**UNITED STATES
NUCLEAR REGULATORY COMMISSION**
WASHINGTON, D.C. 20555-0001

**SUBJECT: GRAND GULF NUCLEAR STATION, UNIT 1 – APRIL 23-25, 2014, AUDIT
REPORT REGARDING MAXIMUM EXTENDED LOAD LINE LIMIT ANALYSIS
PLUS AMENDMENT INCLUDING MINIMUM STABLE FILM BOILING
TEMPERATURE AND QUENCH MODEL (TAC NO. MF2798)**

AUDIT REPORT
MINIMUM STABLE FILM BOILING TEMPERATURE
AND QUENCH MODELS
ENTERGY OPERATIONS, INC.
GRAND GULF NUCLEAR STATION, UNIT 1
DOCKET NO. 50-416

Figure 1: Sample Hofmann Temperature Trace 43w

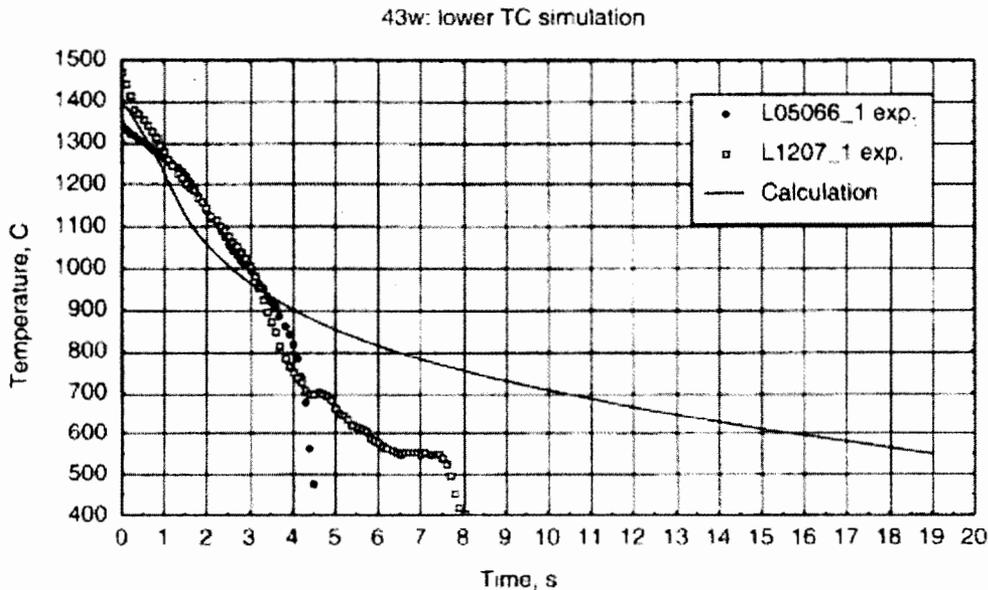
In addition to the Halden test data, the NRC staff also reviewed the use of the Hofmann low-pressure quench data. Several lower pressure tests were conducted to study quenching by Hofmann, et al. (Reference 11). These tests considered variation in oxide layer thickness between 0 and 300 microns on zircaloy. GEH staff went through a screening process to determine if each Hofmann test quenched and the temperature at which the quench occurred if present. The screening process was based on engineering judgment and evaluation without any rigorous criteria. For example, if a steep (defined by GEH at this audit as greater than about 300 K/s) and continuous drop in temperature to saturation temperature was seen, it was categorized as an “obvious quench.” If the quench was not categorized as obvious, the data was not used in the validation. As an illustrative example, the staff considered the GEH classification of TC measurement data from the 43w test (this test was conducted at a peak temperature of 1400 degrees Celsius ($^{\circ}\text{C}$), with 300 microns of oxide, and quenched with water). From the results, GEH concluded that an obvious quench occurs at around 7.5 seconds from about 550 $^{\circ}\text{C}$ as indicated by L1207_1 in Figure 1. However, the change in heat transfer occurring around 800 $^{\circ}\text{C}$ at 3.5 seconds in the L05066_1 trace was not considered as viable quench data.

During analysis of the “obvious quench” data by GEH, no substantive difference was observed in the average measured quench temperature or statistical variation. This result was not expected since the oxide layer is expected to have a multi-pronged effect on the physical T_{\min} . However, since the details of the various mechanisms (e.g., surface roughness and material

heat capacity) are not well understood, the 300 micron oxide layer data is no longer being used to support the GGNS MELLA+ submittal.

Figure 2: Hofmann Temperature Trace 20w Lower TC

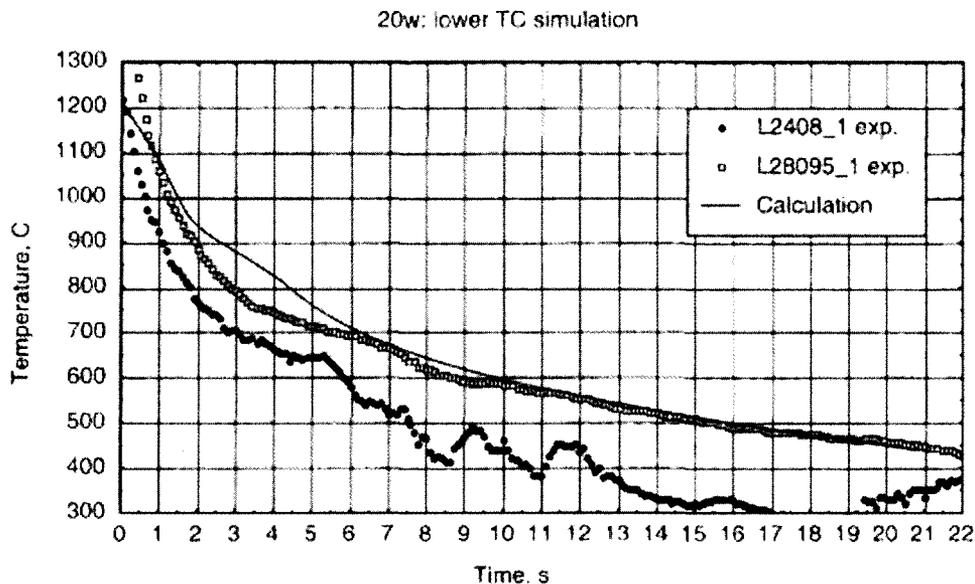
The NRC staff conducted an audit of GEH records indicating which temperature traces were included as obvious quench data. The NRC staff agreed with the GEH determination of those traces which show obvious quench. However, there are some nuances to these data that were not considered in the GEH assessment. The first nuance is that no data from the 0 micron tests were included after the screening. However, several of these tests were excluded because no observed reduction in temperature is reported in the temperature traces from the source report (Reference 11).

Figure 2 provides one such TC response from the 20w test. The experimental data include some temperature oscillation below 600 °C, where the experimenters report that the TC becomes unreliable. However, the indication from the L28095_1 trace appears to indicate a failure to quench for temperatures above 600 °C.

Figure 3: Hofmann Temperature Trace 20w Central TC

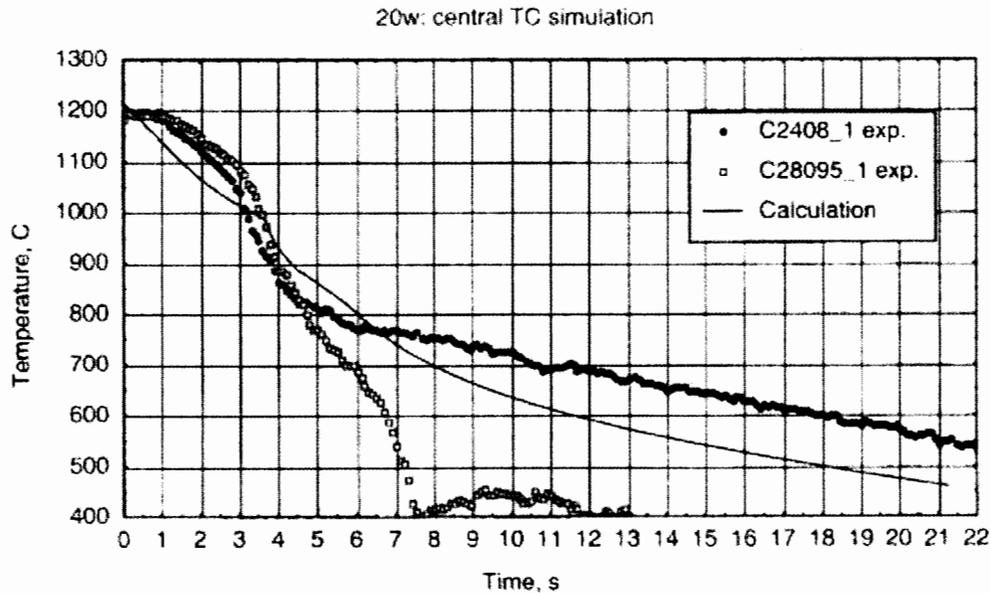
Similarly, Figure 3 shows measurements from the same test at the central TC location. These data also show temperature oscillation below 600 °C, as in the case for the C28095_1 trace, but likewise, a continued high temperature response from the C2408_1 trace. These data can likely be used to establish an upper limit of T_{min} for those traces where no quench is observed. Indication of sufficient liquid inventory for quenching can be inferred by pre-cooling from steam

generation at lower TC locations within the test. For example, test 20w suggests steam cooling coming from water being heated in the lower portion of the test section.

Consideration of data from the 0 micron tests according to looser "criteria" for inclusion appears to be consistent with the Shumway correlation predictions at lower pressure.
